INDEPENDENT TECHNICAL REVIEW OF THE HANFORD TANK FARM OPERATIONS

JULY 1992

**CONDUCTED BY THE
U.S. DEPARTMENT OF ENERGY
OFFICE OF ENVIRONMENTAL RESTORATION AND
WASTE MANAGEMENT
WASHINGTON, D.C. 20585**

Figure F-1. Laboratory Capability and Capacity is the Critical Path in Making "Things Happen."

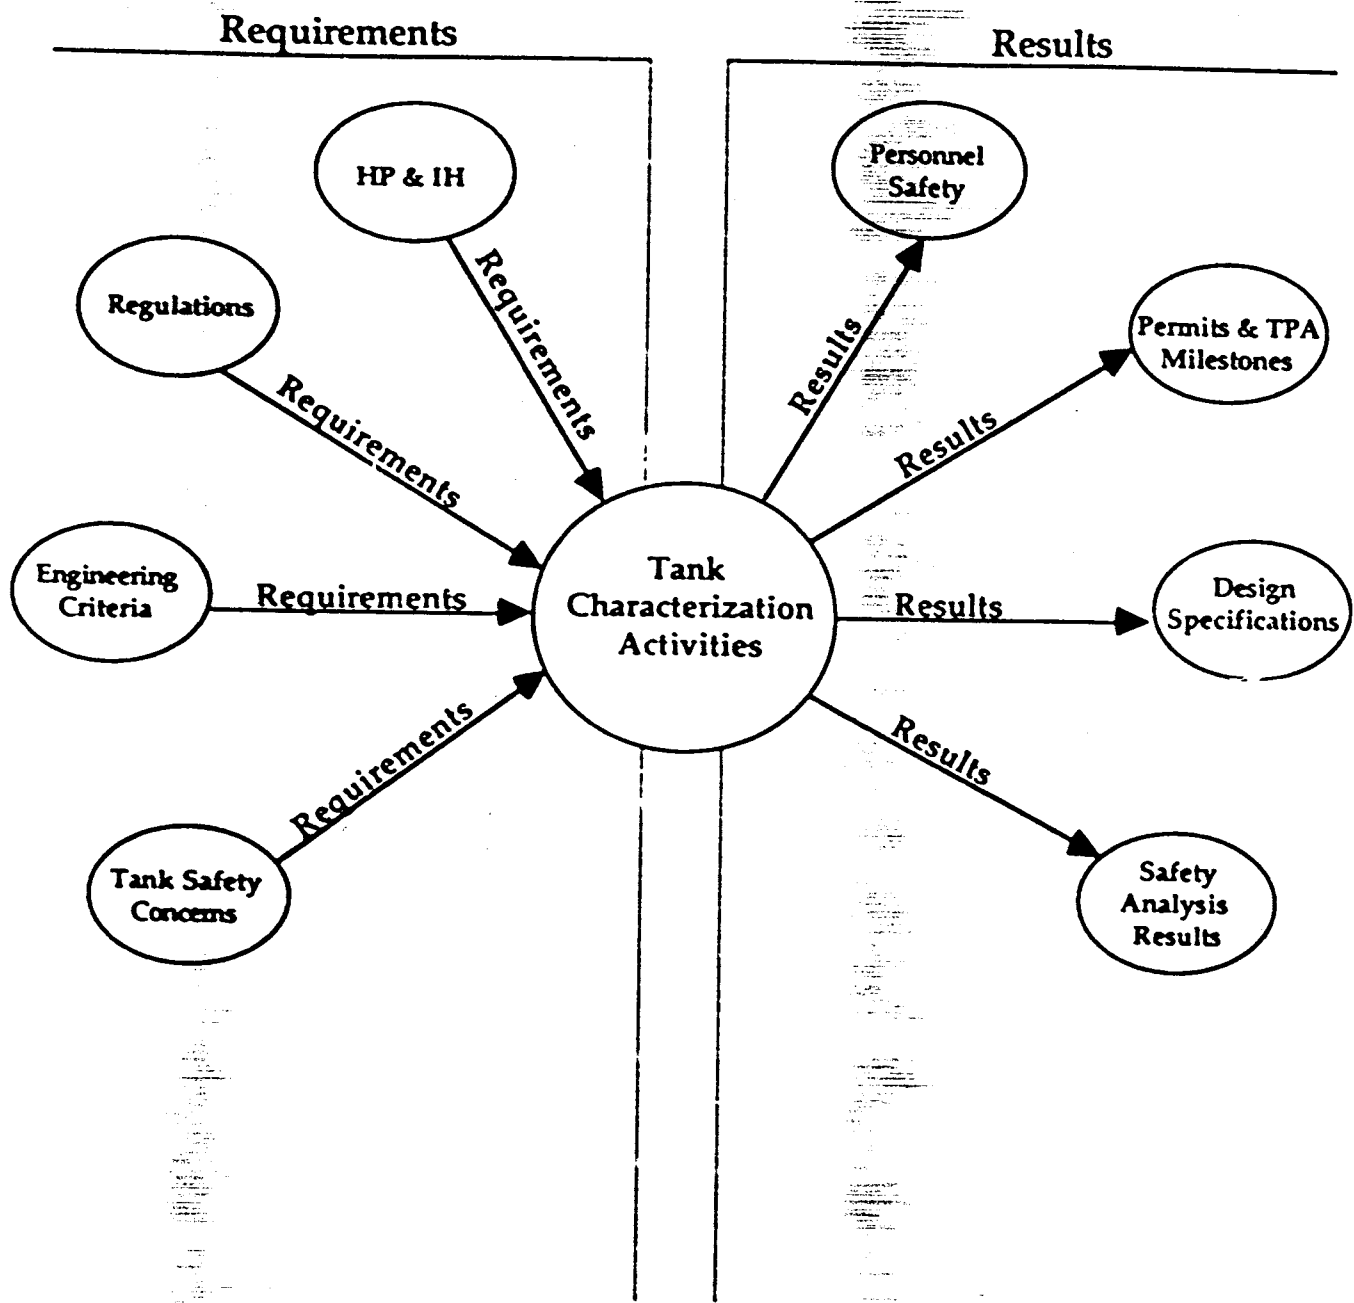
The importance of this waste analysis can be seen by reviewing Figure F-1, which illustrates the multiple requirements for the analysis and indicates the items that are dependent on the results. The recent integration of the sampling needs is a step in the right direction because it attempts to quantify the demands on the laboratory facilities. However, the emphasis remains on meeting the demands of the current project schedules and does not account for new needs that might be identified, nor does it allow for accelerating the analysis to enable the obtaining of needed information earlier than called for on the basis of current planning. (It should be noted that the analytical schedules developed for projects were based not on when the information would be needed, but on when it could be obtained.)
